# Technical Service Information

## SATURN TAAT

### FALLS OUT OF DRIVE AT A STOP

Figure 1

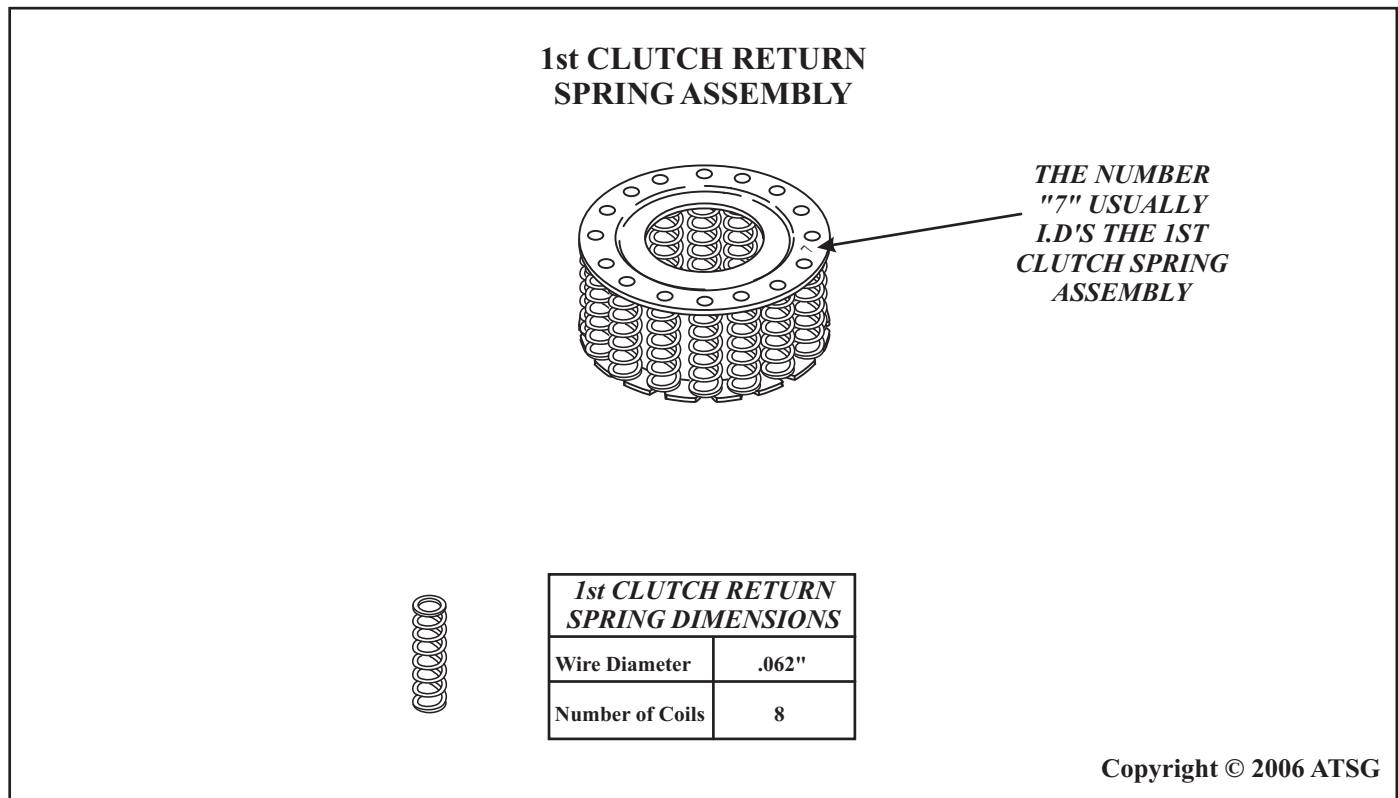
**COMPLAINT:** After overhaul, Saturn vehicles equipped with the MP6 or MP7 transaxle, may exhibit a complaint of falling out of "Drive" at a stop, or a slipping condition on take off.

**CAUSE:** The cause may be, that during overhaul, the 2nd, 3rd or 4th Clutch return spring assembly was mistakenly used in place of the 1st Clutch spring assembly. When this happens, the 1st Clutch can not fully engage until line pressure is increased. Refer to Figure 1 and 2 to compare the 1st Clutch return spring assembly to the 2nd, 3rd and 4th. Notice that the coil diameter of the springs, on 2nd, 3rd and 4th are approximately .010" larger and the number of coils are one more than the 1st which makes them stronger.

**CORRECTION:** Refer to Figure 1 to identify the 1st Clutch return spring assembly, and ensure it is in the correct location.

Figure 2

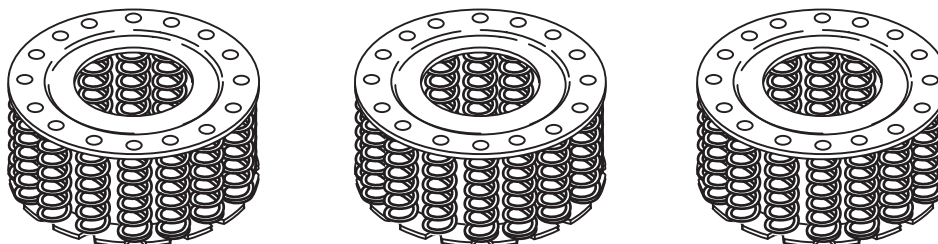
<i>2nd, 3rd and 4th CLUTCH RETURN SPRING DIMENSIONS</i>	
Wire Diameter	.072"
Number of Coils	9
